UNITED STATES PATENT AND TRADEMARK OFFICE

Office Action Summary	Application No. 09/994,741	Applicant(s) BLATTNER ET AL.	
	Examiner Erica E. Cadugan	Art Unit 3722

DETAILED ACTION

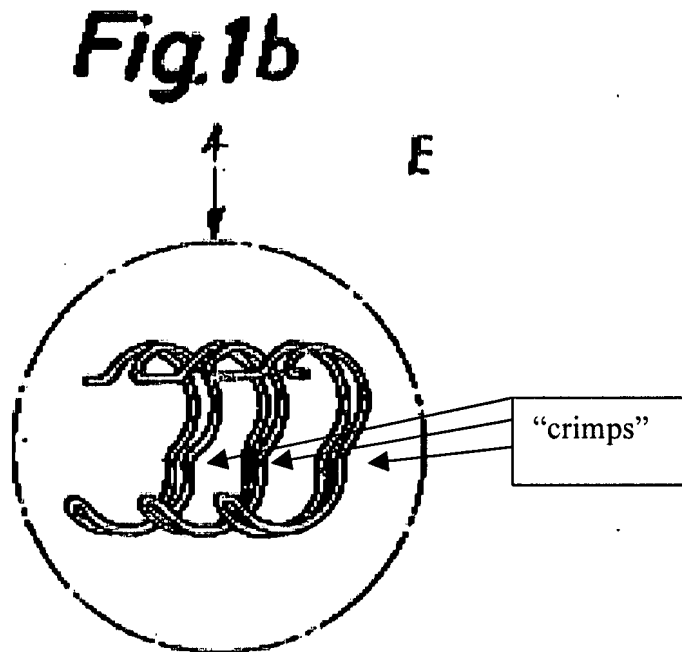
Re claim 25, it is noted that at least the section so indicated in the reproduction of Figure 1b below can be considered to be a “crimp” that is “formed” in a loop of the looped binding element.

Noting that the wire begins Fabrig's manufacturing process shown in Figure 1 as unbent wire 1 that is then passed through bending station A to bend the wire into a flat comb-like body 3, and then into a bending machine B to transform the flat comb-like body into the configuration 4 shown in Figure 1b, whatever structure is inherently present in the bending tooling of Fabrig to produce the crimped configuration shown in Figure 1b from the unformed wire 1 is considered to be the claimed "crimping device" of claim 25.
